UNITED STATES PATENT AND TRADEMARK OFFICE

APPLICATION NO.	FILING DATE	FIRST NAMED INVENTOR	ATTORNEY DOCKET NO.	CONFIRMATION NO.
09/661,057	09/13/2000	Akira Ohtani	Q60771	7619
7590	11/12/2003		EXAMINER	
Sughrue Mion Zinn MacPeak & Seas PLLC 2100 Pennsylvania Avenue NW Washington, DC 20037-3202			CHOWDHURY, TARIFUR RASHID	
			ART UNIT	PAPER NUMBER
			2871

DETAILED ACTION

FIG. 11

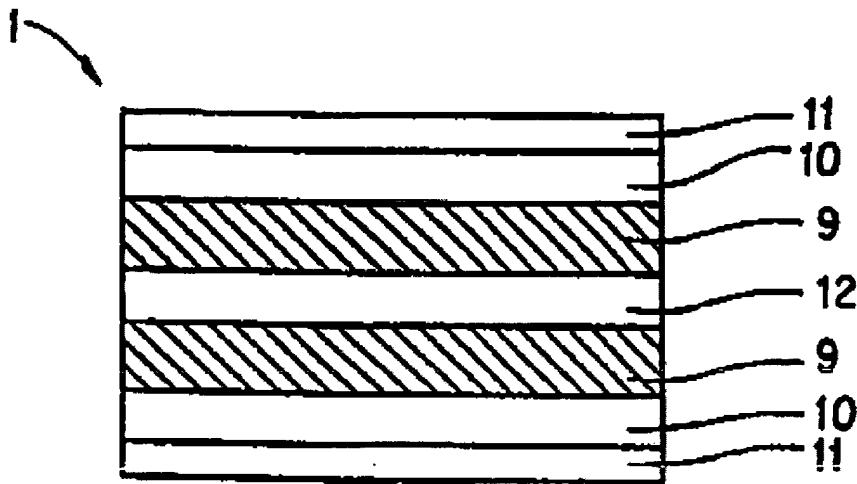
4. Hinata discloses and shows a liquid crystal cell substrate comprising a polycarbonate film supporting substrate (9) (applicant's resin substrate) and, closely adhered thereon, a gas barrier layer (10), a resin hard coat layer (11) and a polarizing layer (12) (Fig. 11, col. 5, lines 33-38).

As to claim 7, Hinata shows in Figure 11, that the polarizing layer (12) is in contact with one side of the supporting substrate (9) (applicant's resin substrate).

As to claim 8, Hinata shows in Figure 11, that the polarizing layer (12) is in contact with one side of the supporting substrate (9) (applicant's resin substrate).
